737

Service Bulletin

Number: 737-21-1186
Original Issue: April 17, 2012
Revision 1: April 23, 2015
ATA System: 2130

SUBJECT: AIR CONDITIONING - Control Cabin Conditioned Air Distribution System - Inspection of the Metal Clamp Installed on Hoses to the Air Conditioning Temperature Sensor, Gasper Air Outlet and Diffuser

**FIGURE 1: HOSE GENERAL VISUAL INSPECTION
(SHEET 1 OF 3)**

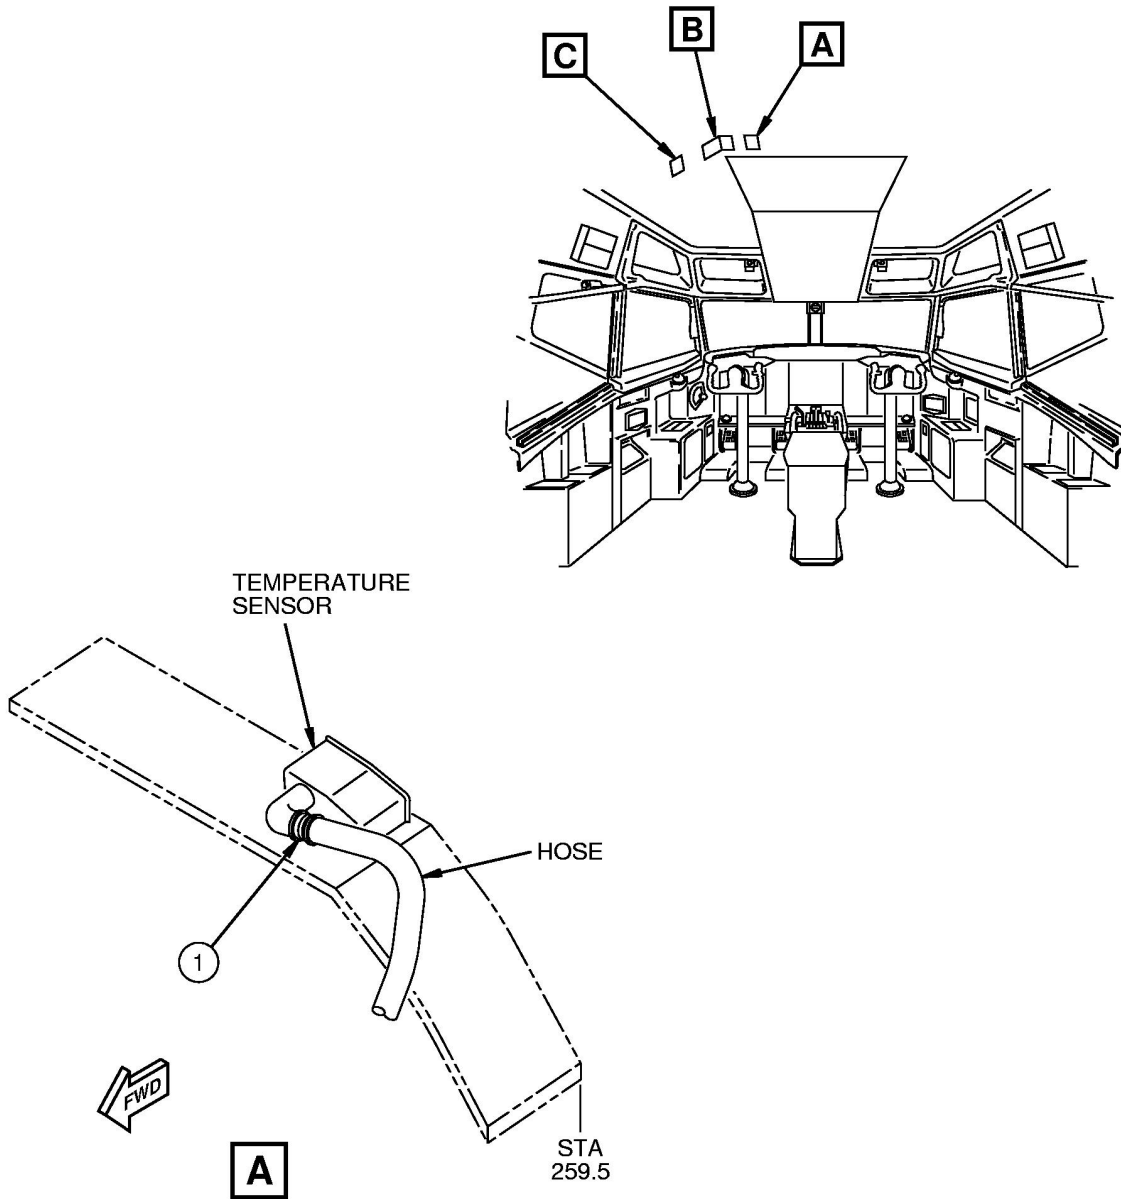
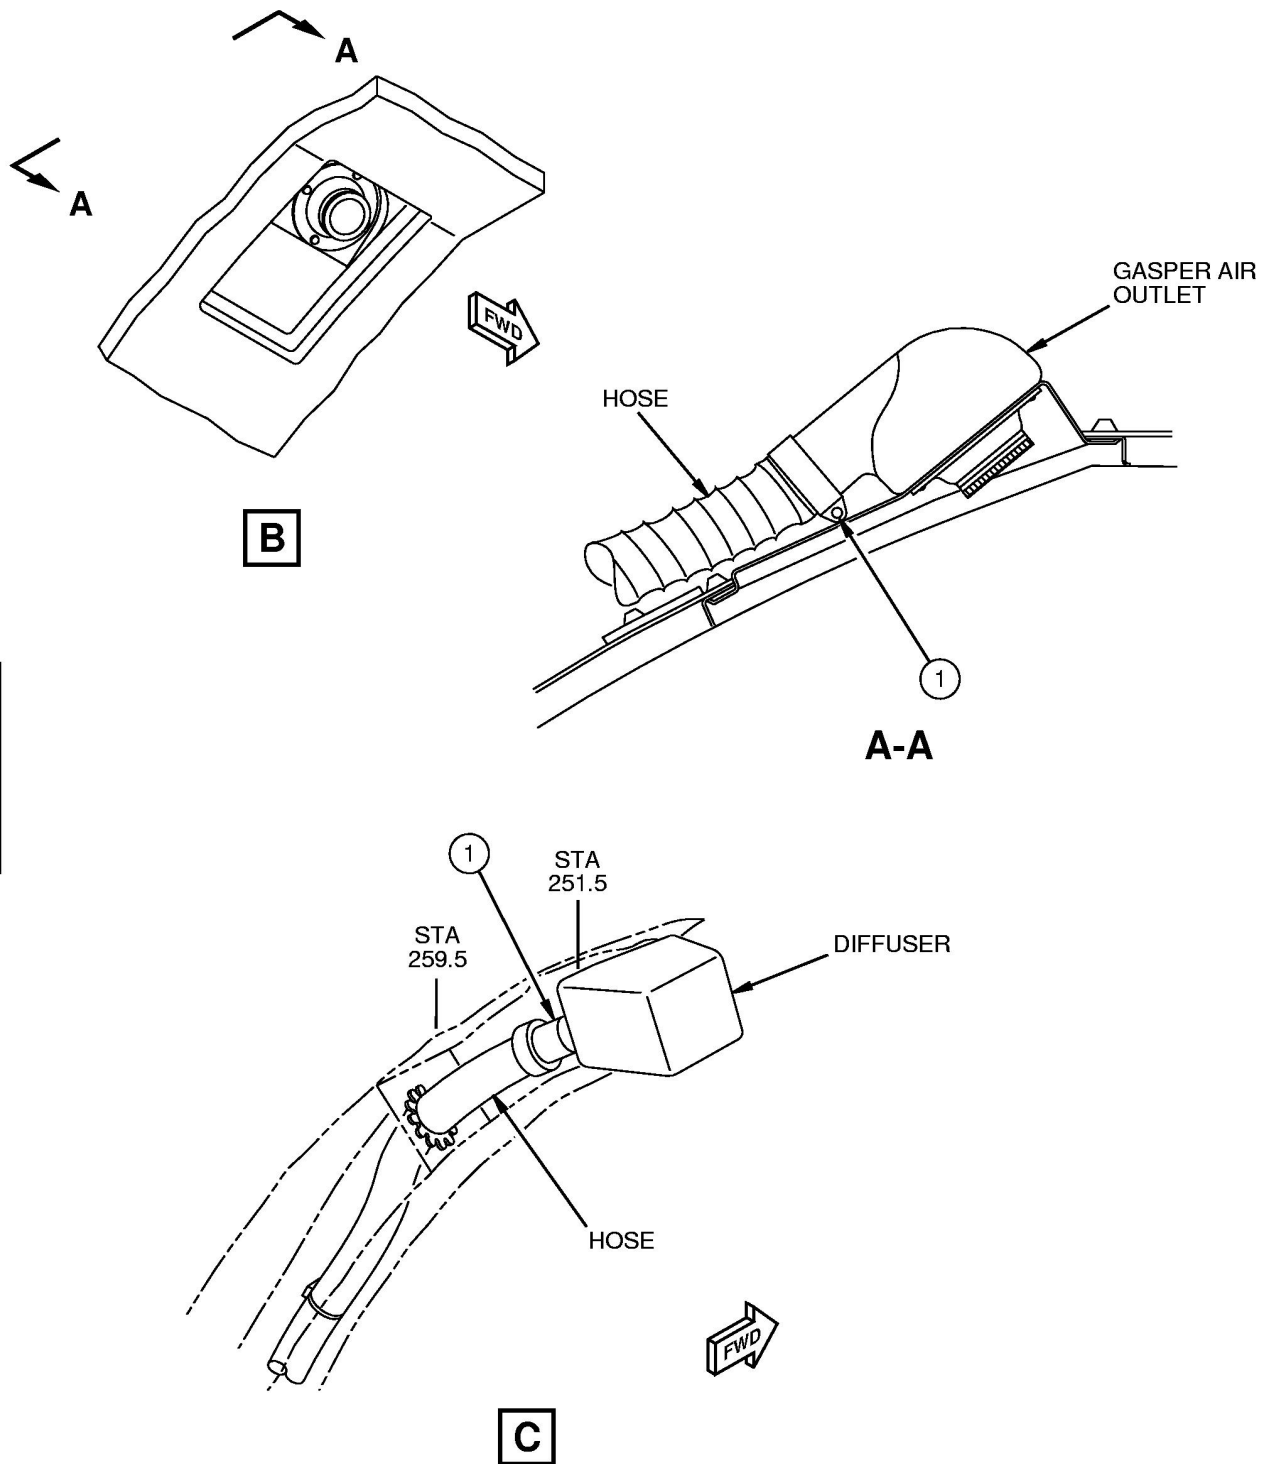
- a. Condition 1 - Metal clamp found

- b. Condition 2 - Plastic tie strap found installed with head not pointed towards the panel.

Step	Task	Name	Identification	Qty	More Data
1	Inspect	Metal Clamp or Plastic Tie Strap	-	-	(a) (b)
(a) Do a General Visual Inspection (GVI) of hoses for metal clamps or improperly installed plastic tie straps.					
(b) An improperly installed plastic tie strap has the head pointed in any direction, except towards the panel. The correct installation is head of plastic tie strap towards the panel.

**FIGURE 2: PLASTIC TIE STRAP INSTALLATION
(SHEET 1 OF 3)**

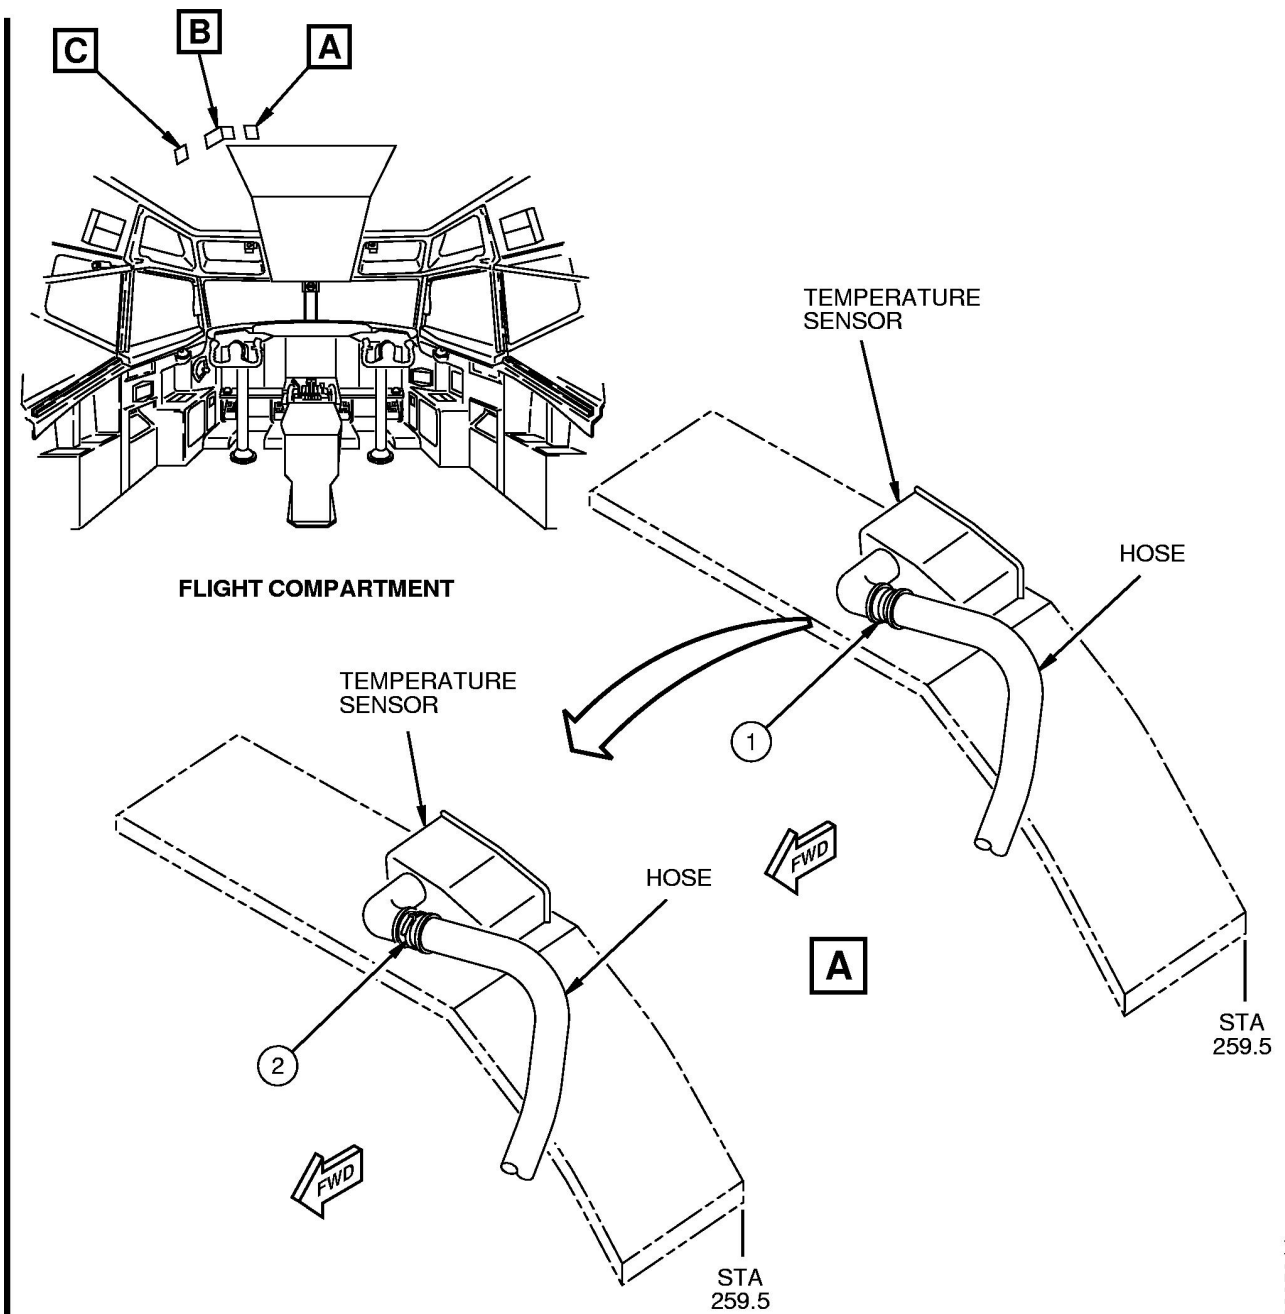
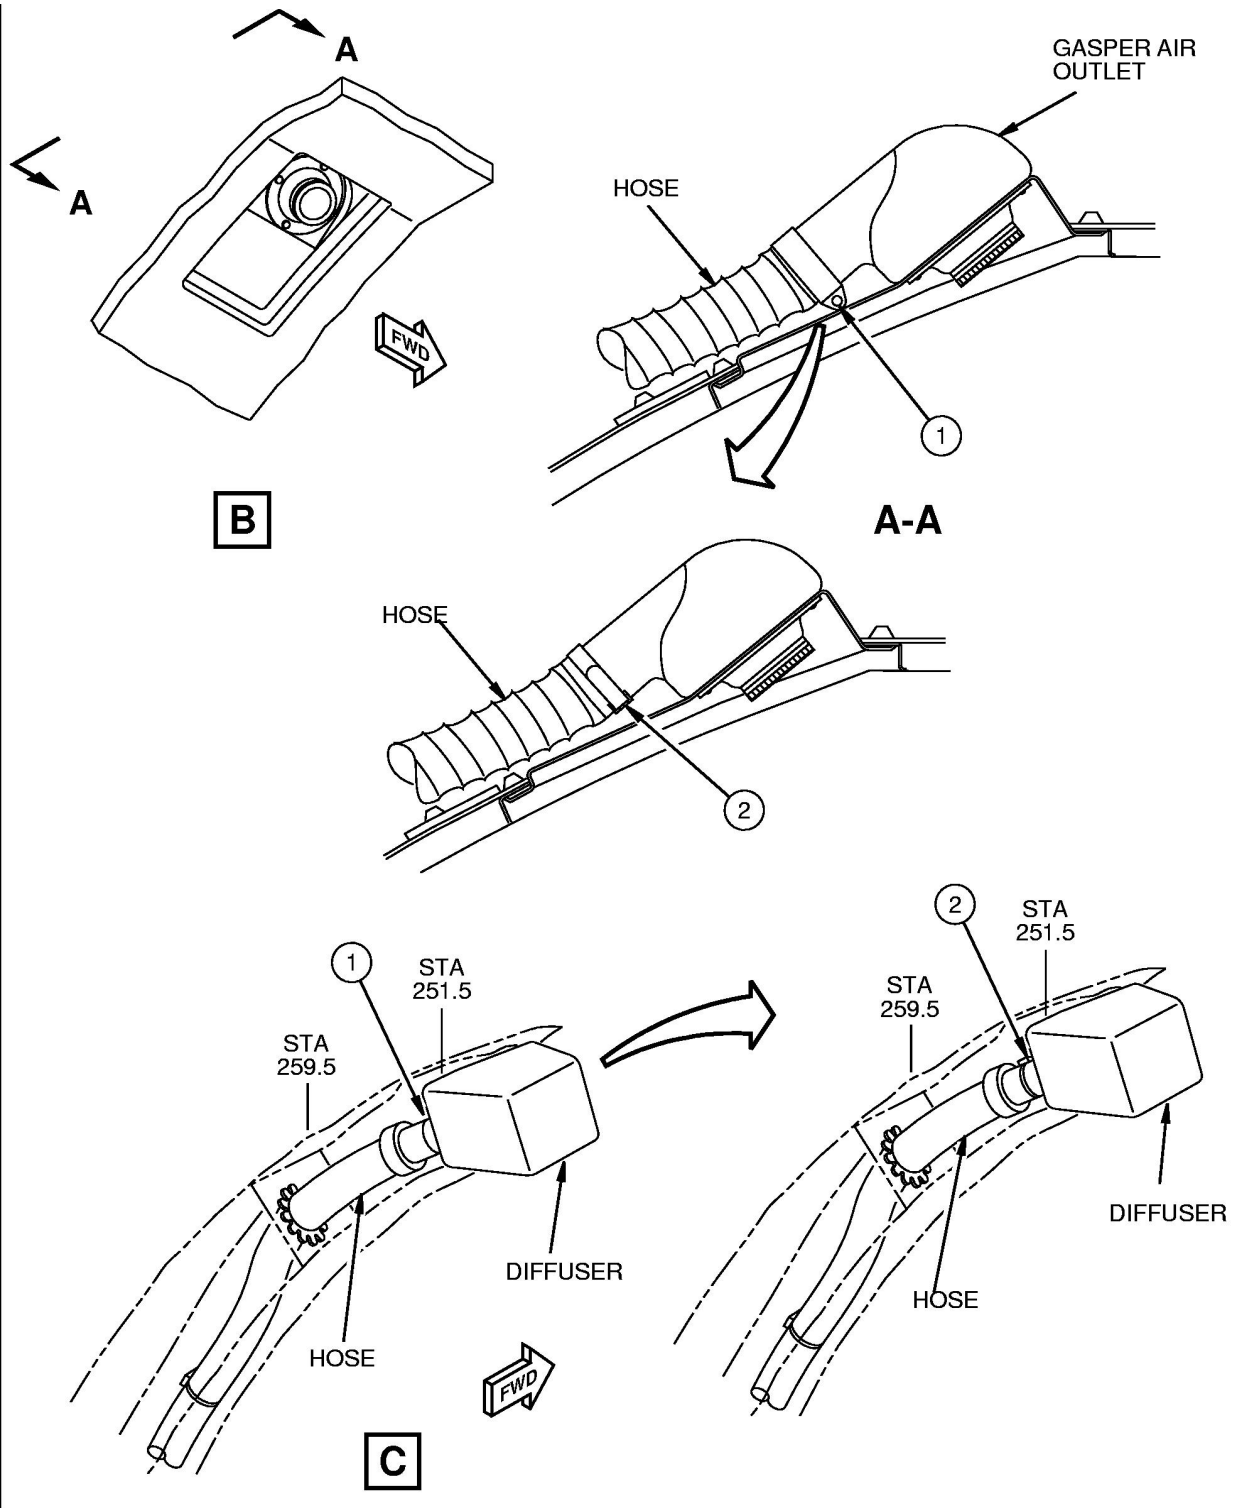
Remove and replace with a plastic tie strap in accordance with the figures in the table below:

Step	Task	Name	Identification	Qty	More Data
1	Remove	Metal Clamp or Plastic Tie Strap	-	-	(a)
2	Install (New)	Plastic Tie Strap	BACS38K7	-	(b) (c)
(a) Quantity may vary for each airplane.					
(b) Install the plastic tie strap with head pointed towards panel. Refer to AMM 737-100/200 AMM 21-22-09 or 737-300/400/500 AMM 21-22-09 as an accepted procedure.					
(c) Use a tension setting between 18-22 inch pounds. Refer to SWPM 20-10-11 as an accepted procedure.
